UNITED STATES PATENT AND TRADEMARK OFFICE

10/571,880

| Office Action Summary | Application No. 10/571,880 | Applicant(s) WEHLER, HERBERT | |

FIG. 3

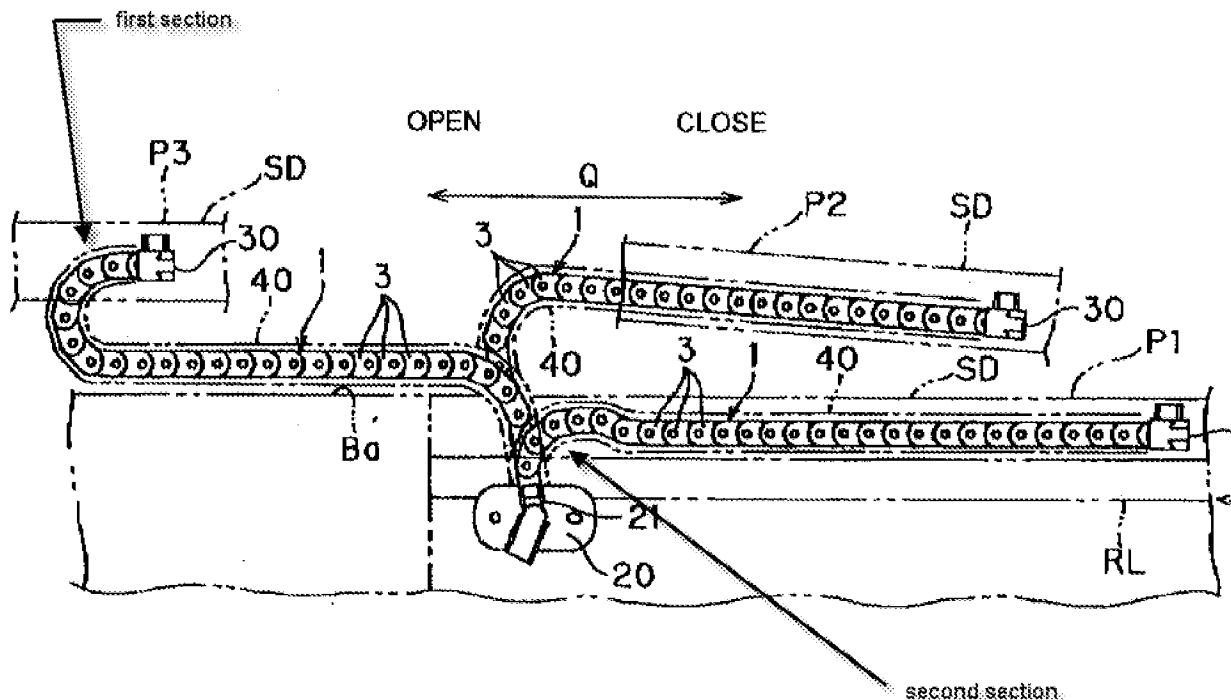
Claim 22 is rejected under 35 U.S.C. 102(e) as being anticipated by Kobayashi et al. (US 2004/0003543). Kobayashi et al. discloses an energy guide chain system for a vehicle, the vehicle having a chassis B and a sliding door SD that can be moved between a closed position and an open position on the chassis, and the energy guide chain system comprises:

a region (not numbered, but shown in figure 3) between the first end and the second end and the region bends in a single direction, and the region has a first section (labeled below) that defines a first radius of curvature when the sliding door is in the open position, and a second section (labeled below) that defines a second radius of curvature when the sliding door is in the closed position.

The applicant's comments concerning claim 22 are not persuasive. The energy guide chain of Kobayashi et al. bends in a single direction as much as the applicant's energy guide chain bends in a single direction. Note that the bends of the energy guide chain of Kobayashi et al. are directed toward the right, i.e., the same direction, in figure 3.
